Design Review Board – Neighborhood Panel

Agenda Workshop

**Planning Staff Report to
Design Review Board - Neighborhood
May 24, 2022**
for the June 2, 2022 Public Hearing

**Planning Staff Report to
Design Review Board - Neighborhood
May 17, 2022**
for the June 2, 2022 Public Hearing

Existing & Proposed
Front & Rear Elevations

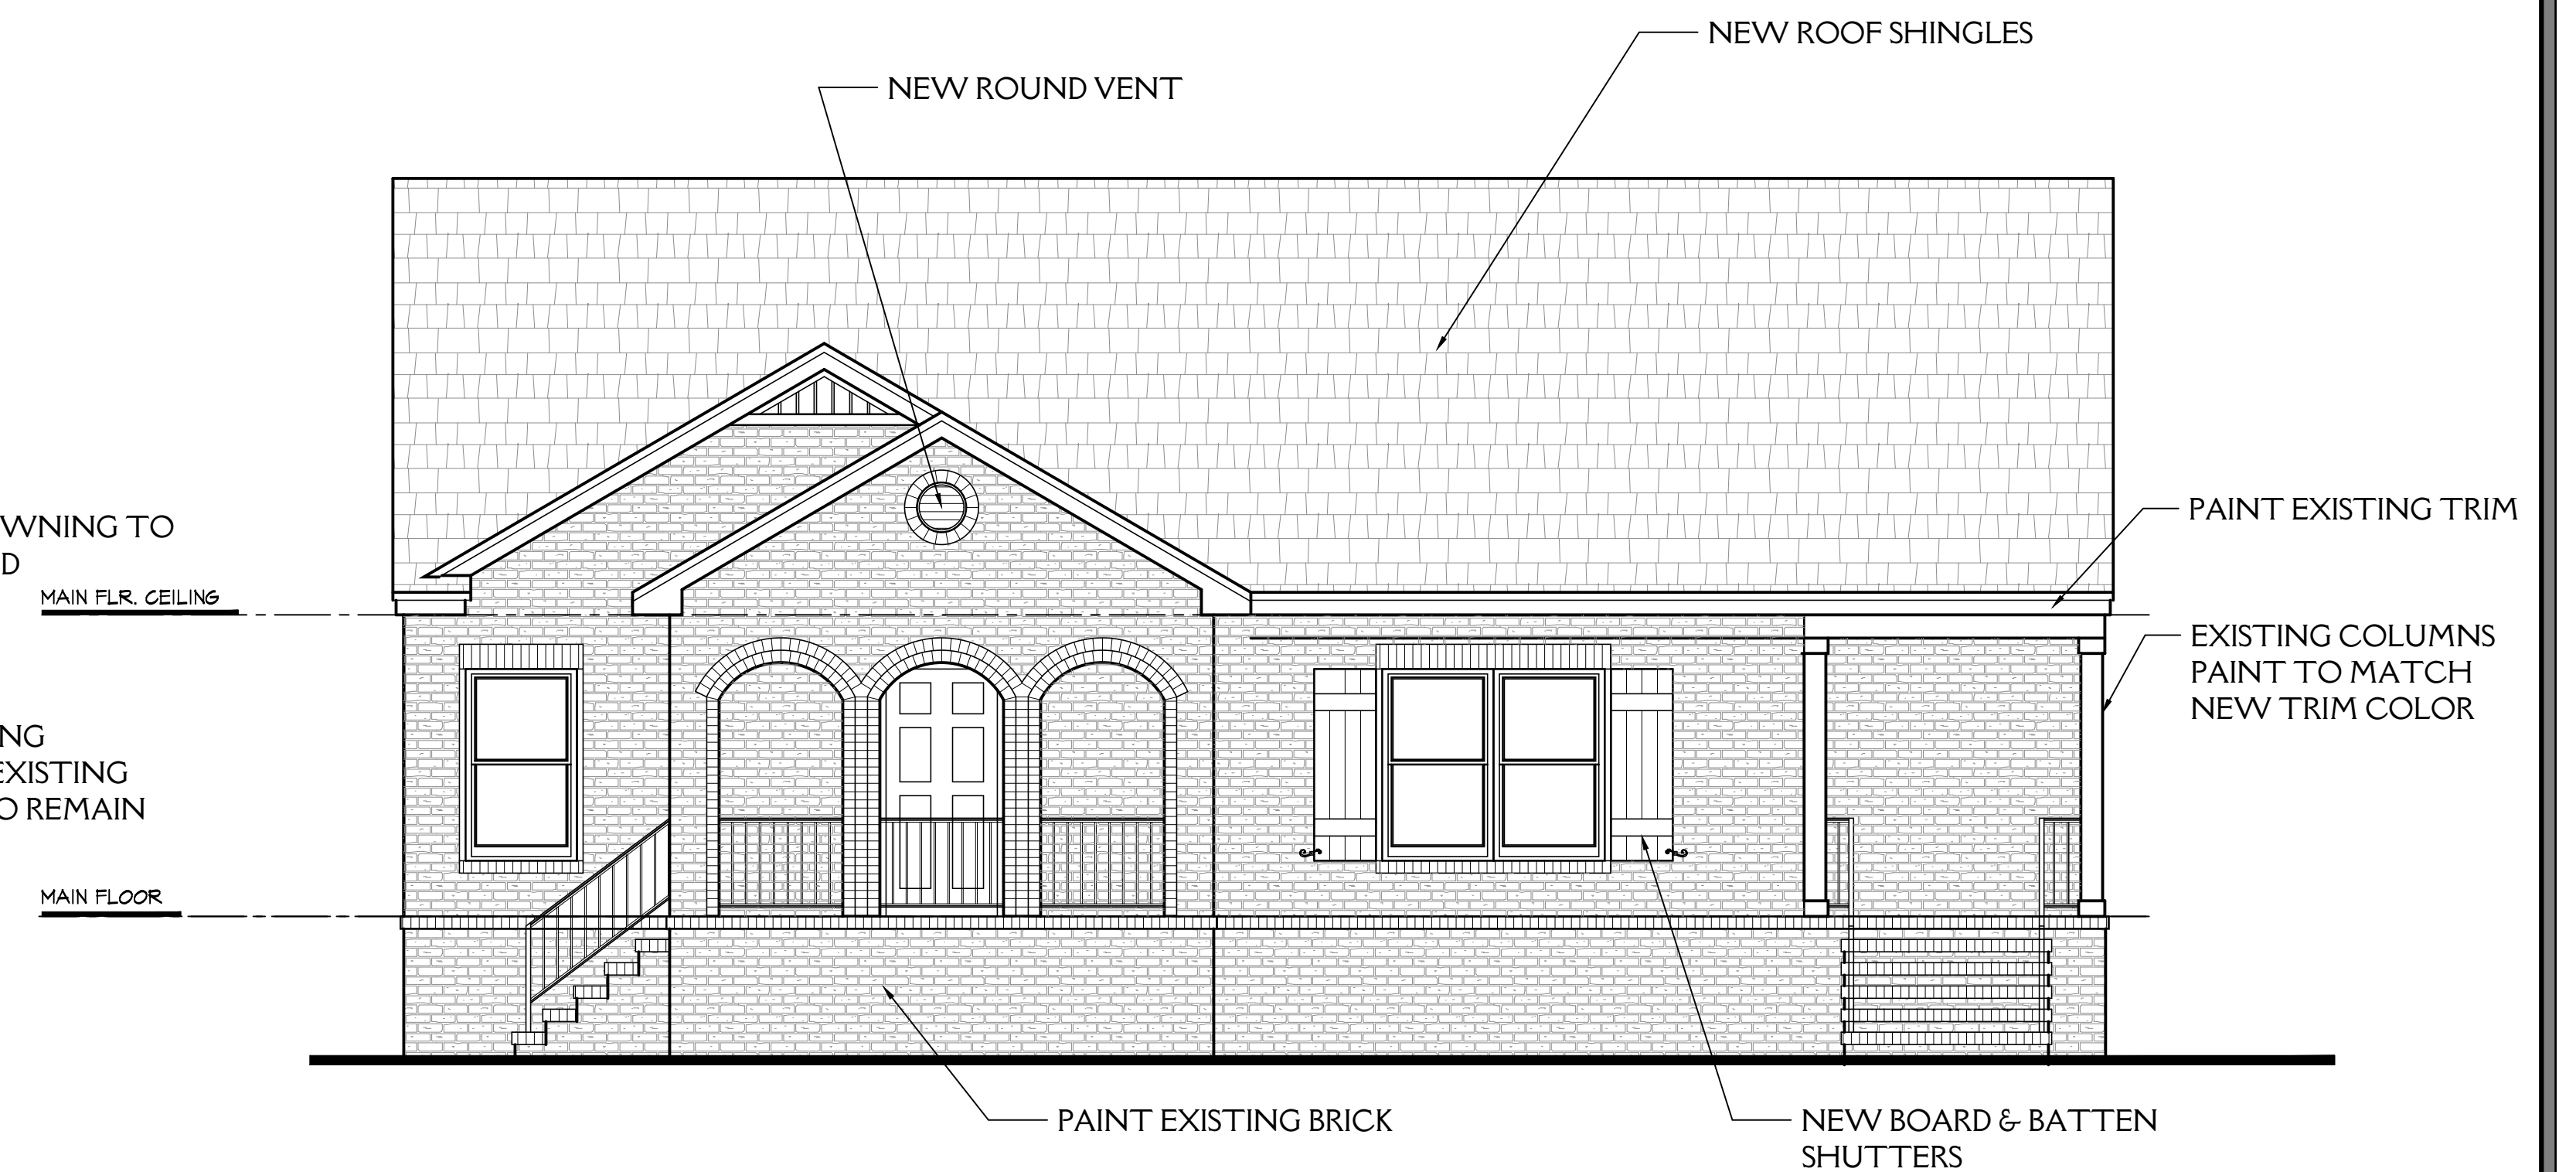
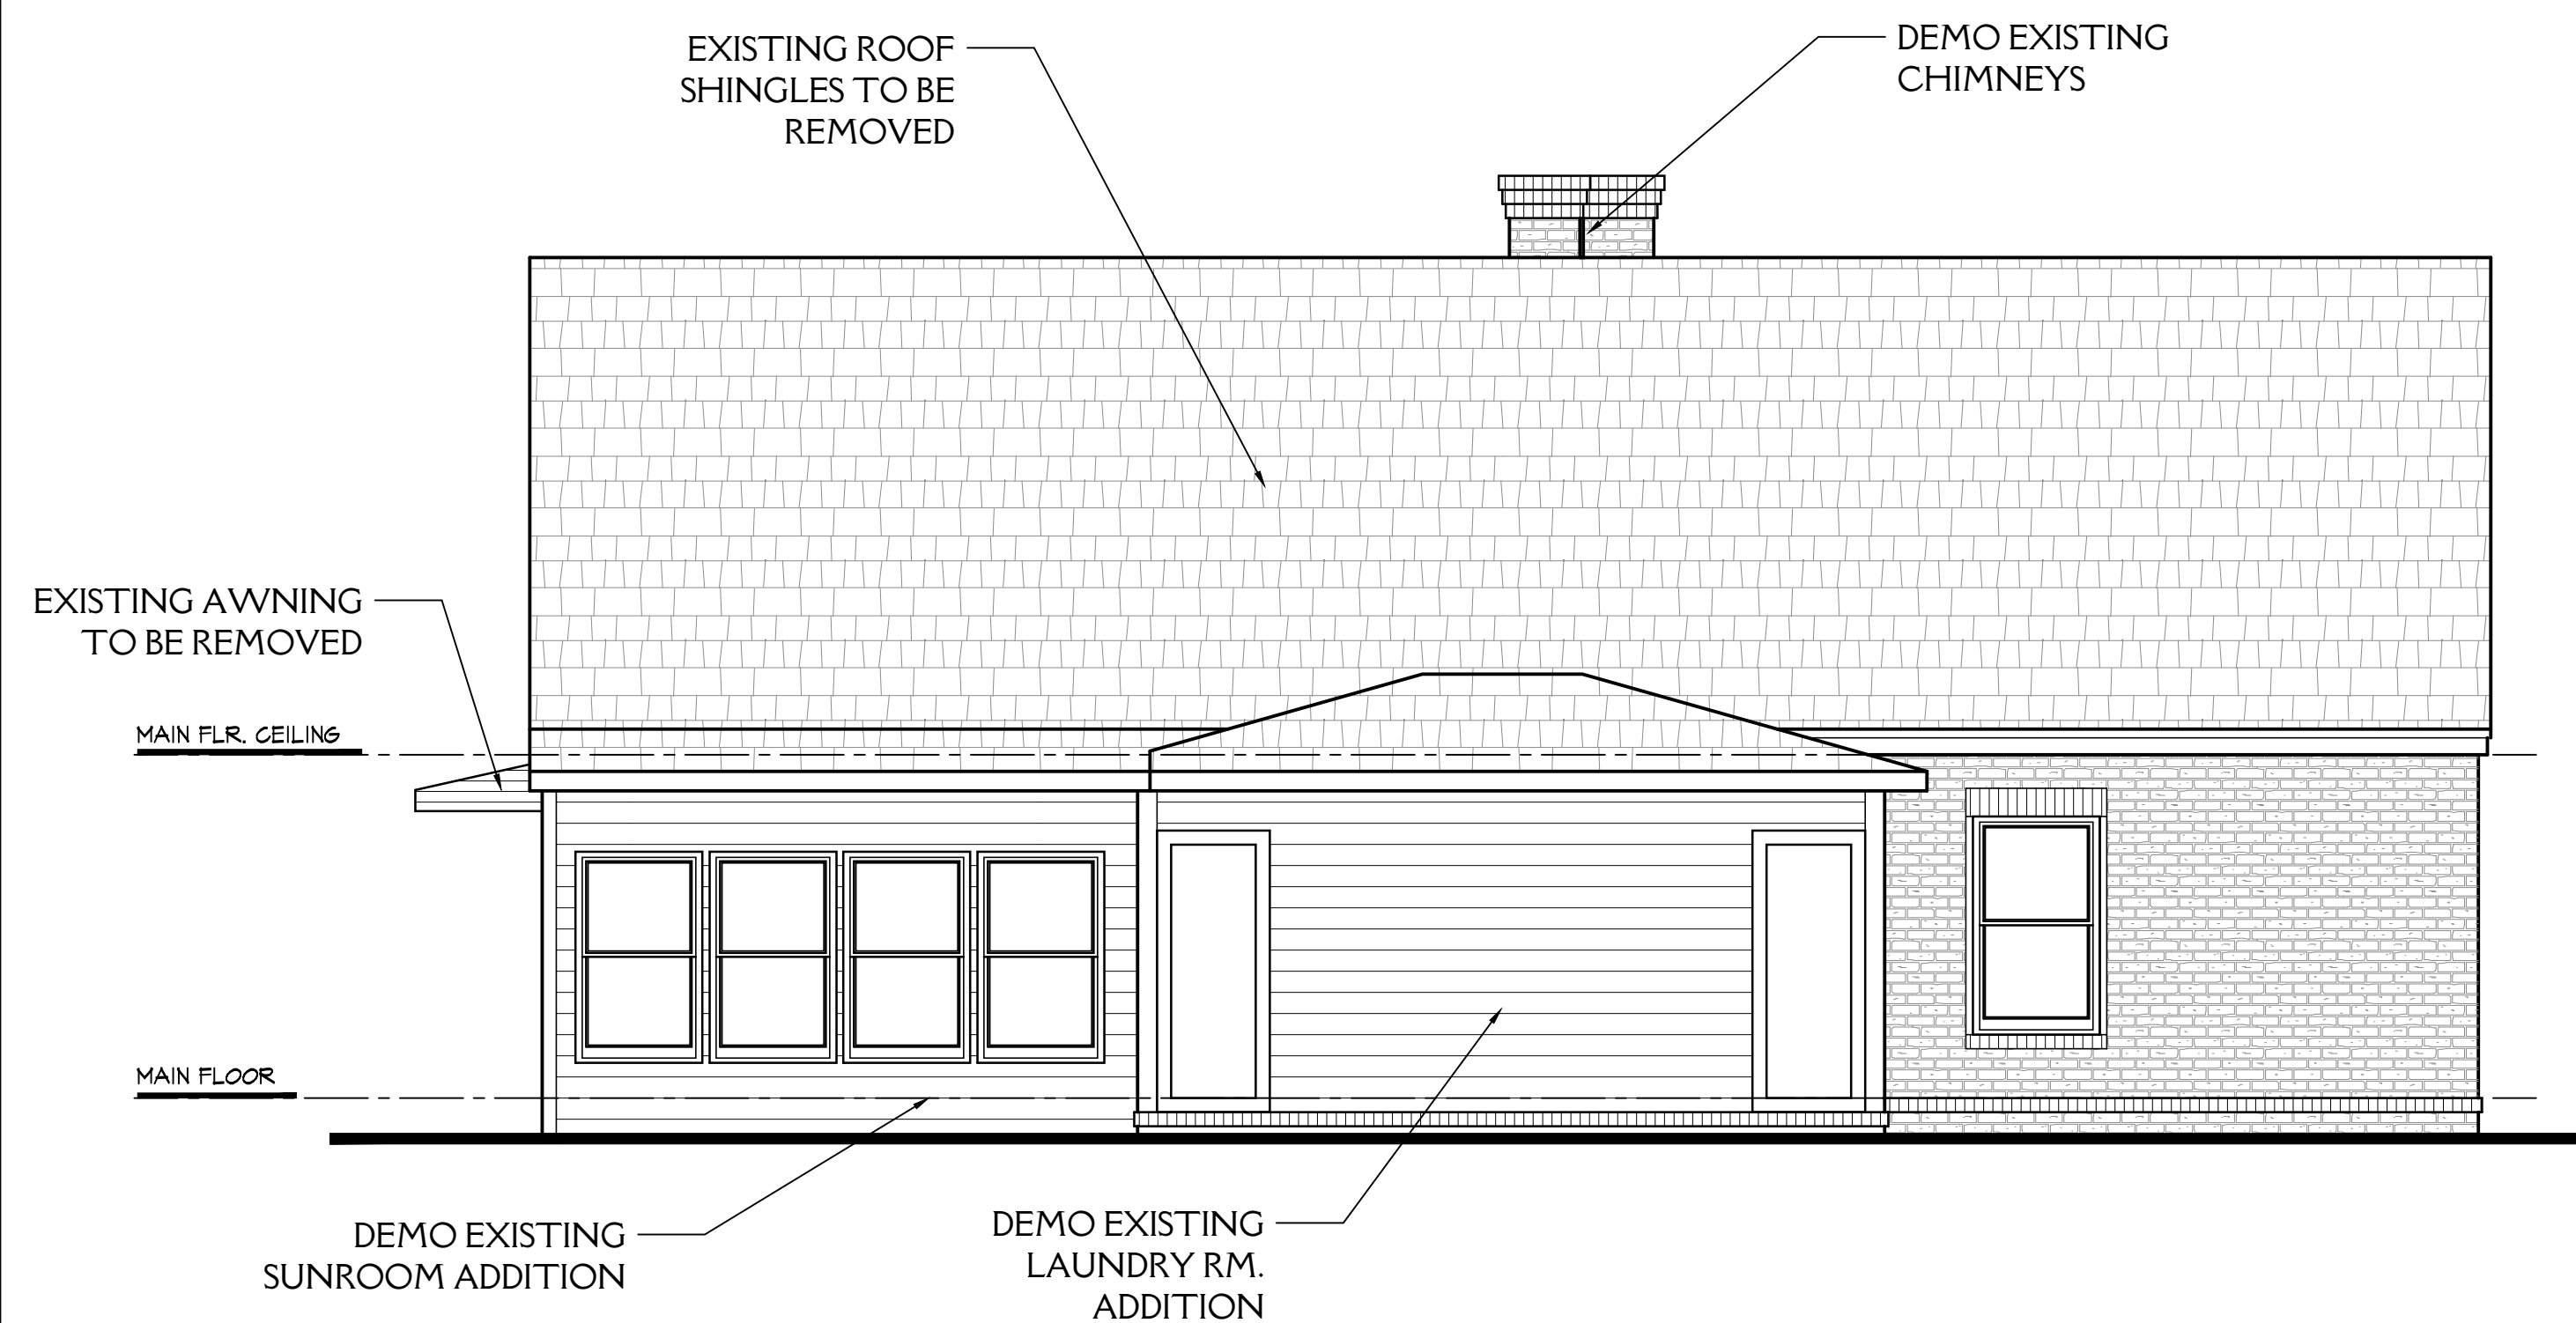
The proposed materials of Hardie Plank are suitable for the new rear addition, but the historic brick should be maintained and preserved on the remainder of the house and not painted as is proposed. HR.9 Masonry Construction, recommends that brick that was not painted historically should not be painted.

Staff finds that removal of the chimneys is not compatible with the design guidelines outlined in Chapter 9. Overbrook Historic District. The introduction specifically calls out chimneys as contributing to the historic district and should be maintained. While Design Guidelines do not dictate interior modifications and would therefore allow for the proposed removal of the fireplaces the existing historic chimneys should be preserved. Structural engineering efforts should be made to maintain the existing elevation of the house.
